ADDENDUM NO. 1

**FORT WAYNE CHILDREN'S ZOO
VELDT BARN REPLACEMENT
MSKTD Project No. 8063
Wednesday, September 11, 2024**

This addendum is issued as a supplement to the drawings and specifications and shall be considered an integral part of the same.

SET DESCRIPTION
SHEET TITLE
Domestic Water Plans
SHEET NUMBER

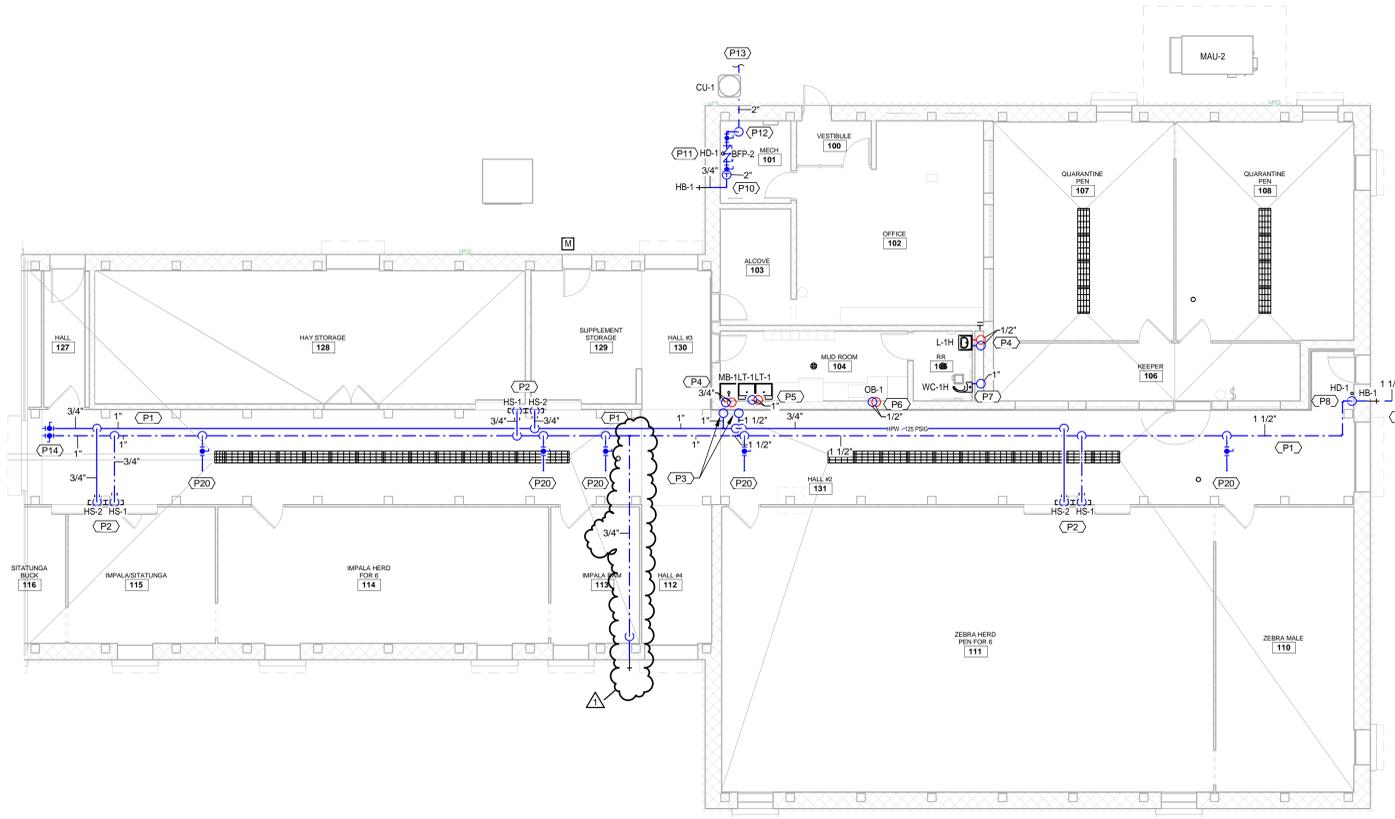
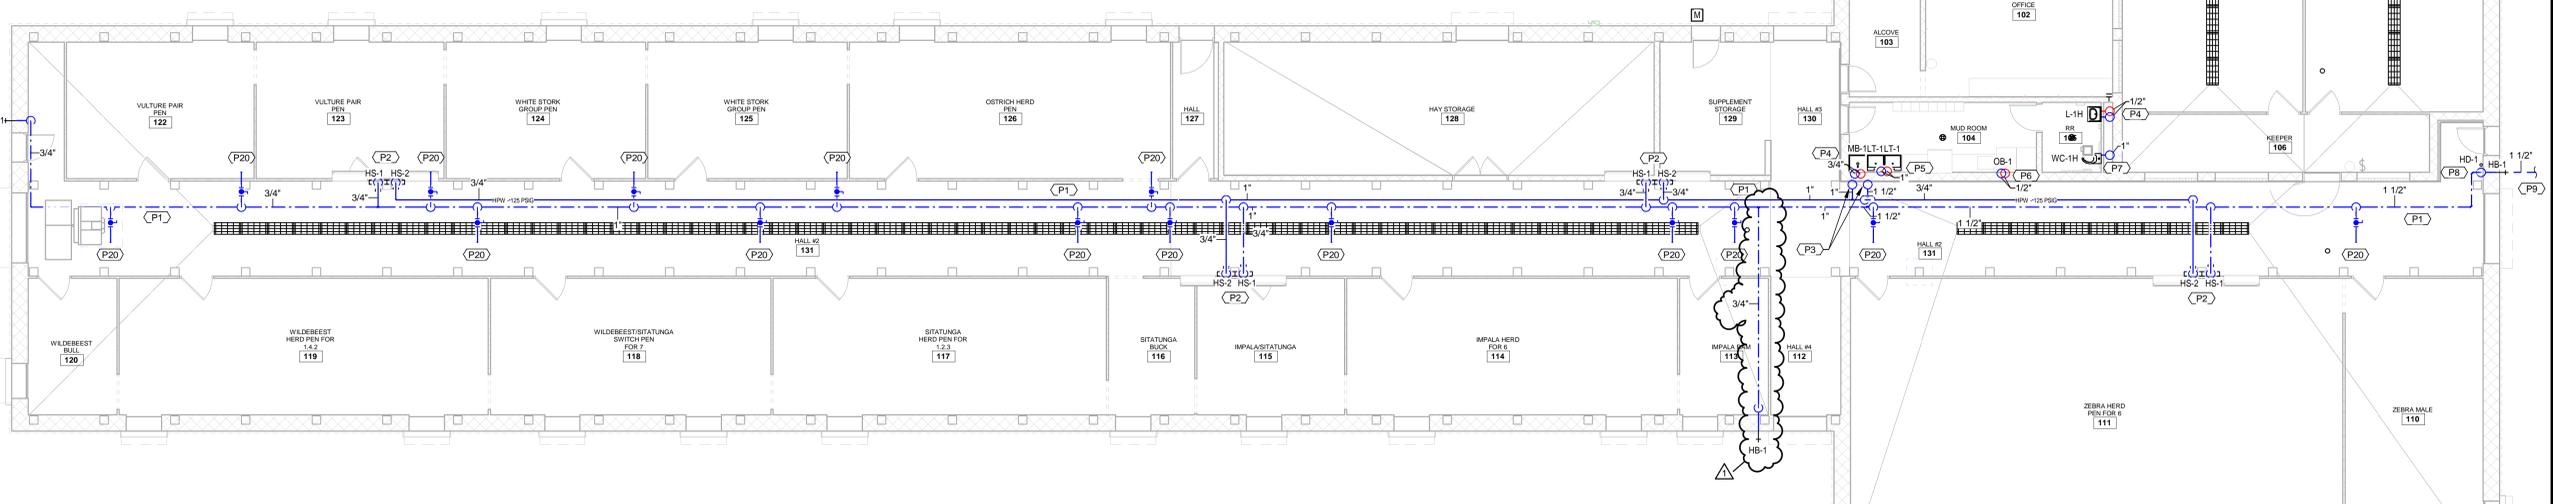
1.24	Drawing Sheet P301	Relocate a hose bibb marked HB-1 from the southwest corner of Zebra Herd Pen 111 to Impala Ram 113 as shown on the attached, revised sheet.

Mechanical Level Electrical Plan
 1/8" = 1'-0"

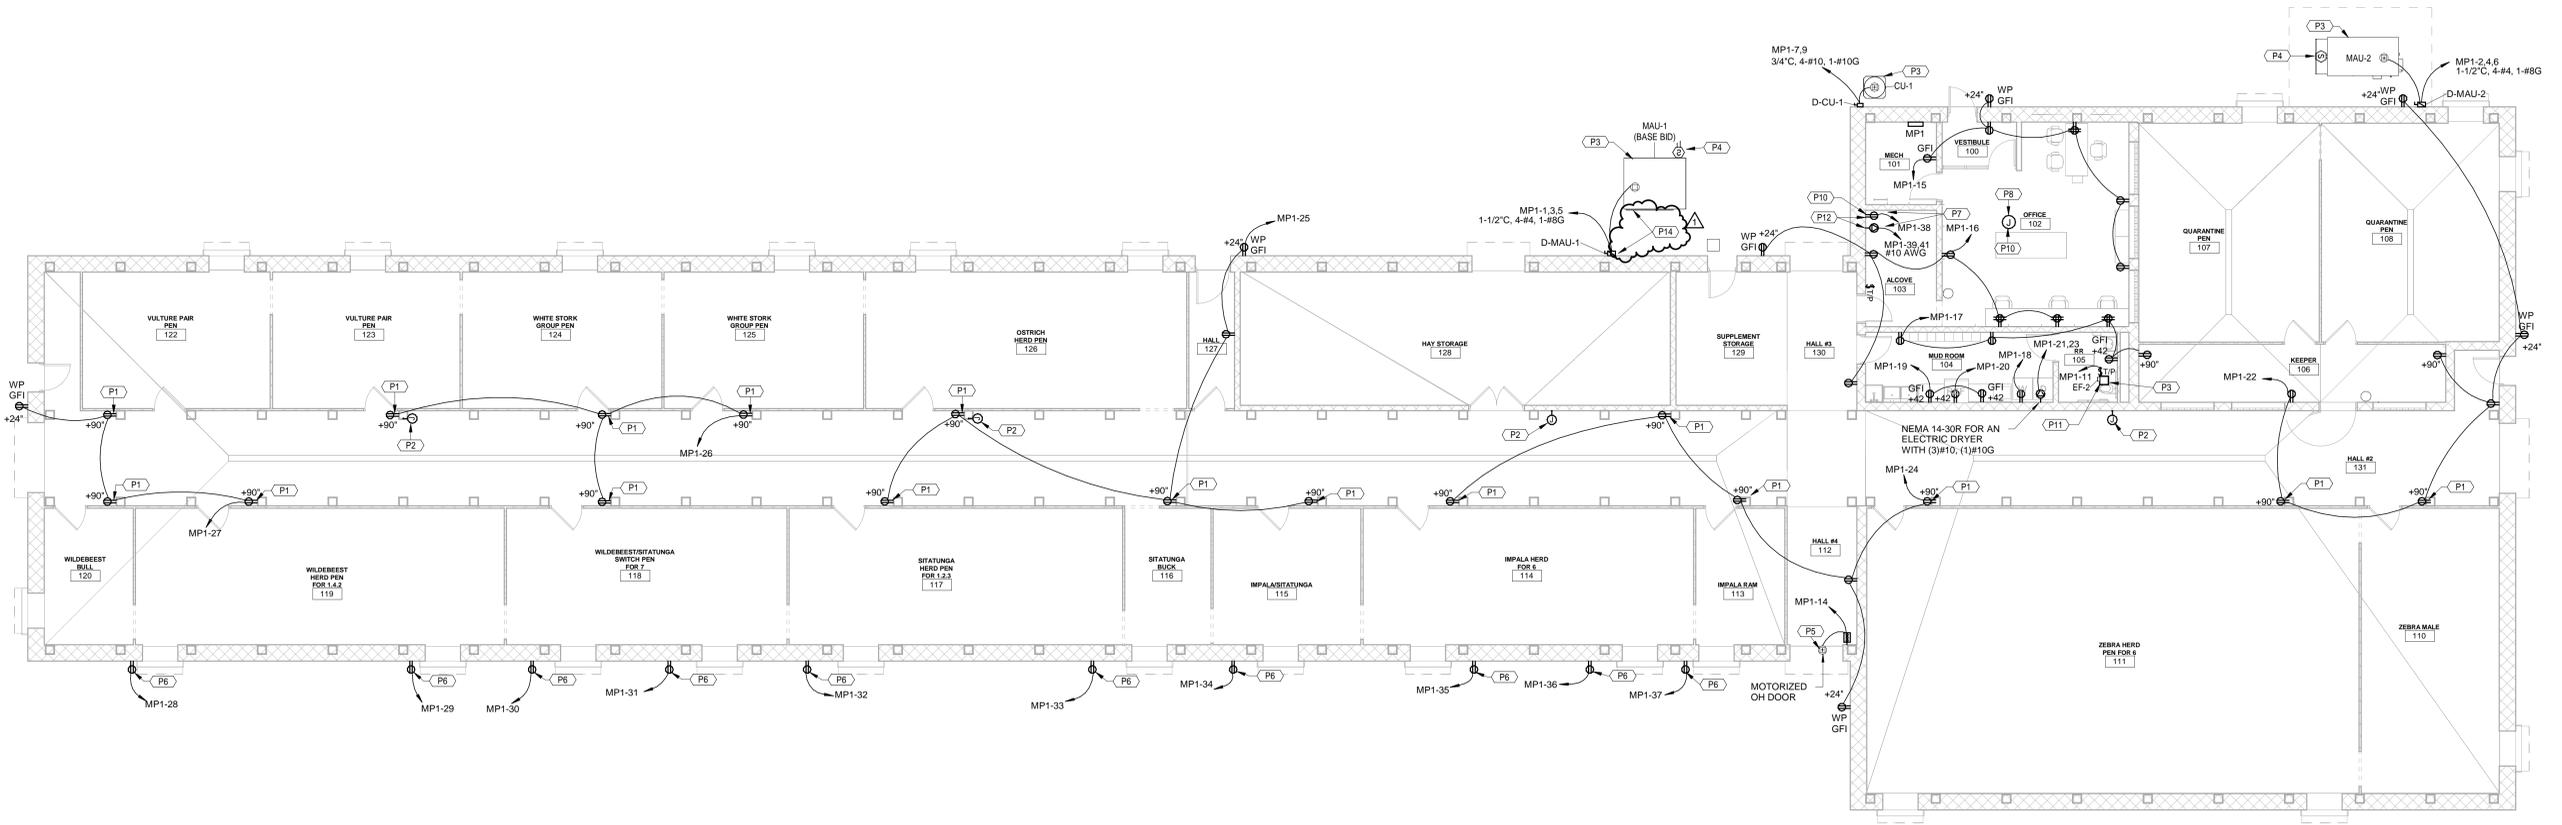
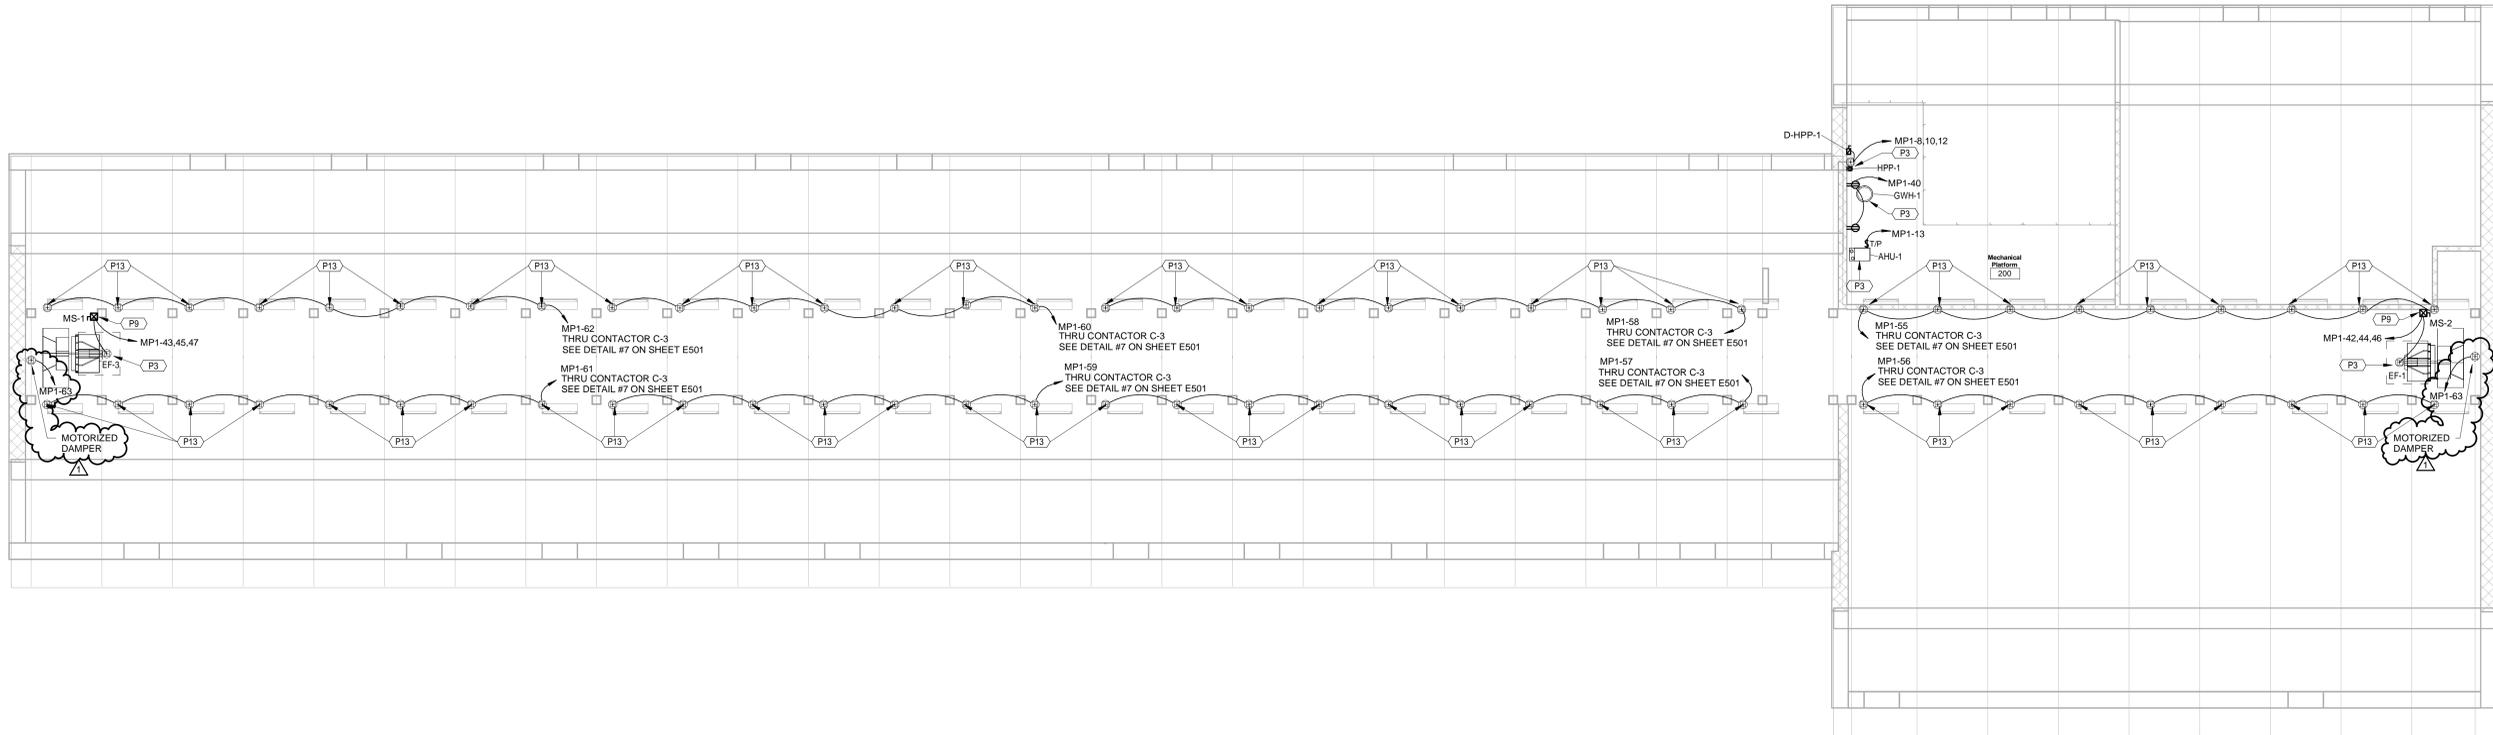
1.25	Drawing Sheet E201	Added Power Plan Note P14 to clarify MAU-1 circuit sizes for Base Bid and Alternate A2.
1.26	Drawing Sheet E202	Added circuits for motorized dampers near EF-1 & EF-3.

6 Electrical Riser Diagram
 1/2" = 1'-0"

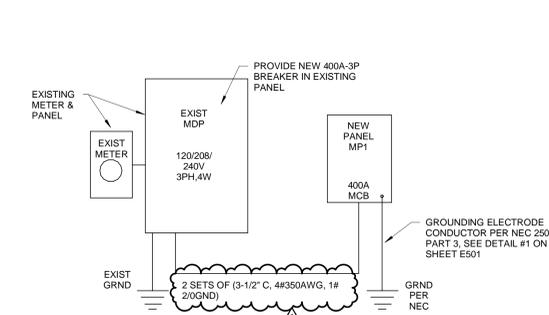
1.27	Drawing Sheet E501	On Detail 1 Structure Grounding: See revised grounding size.
1.28	Drawing Sheet E502	On Luminaire Schedule: Clarified Fluorescent Light FL-1 to be 2-lamp fixture. Electrical Riser Diagram: See revised feeder size.
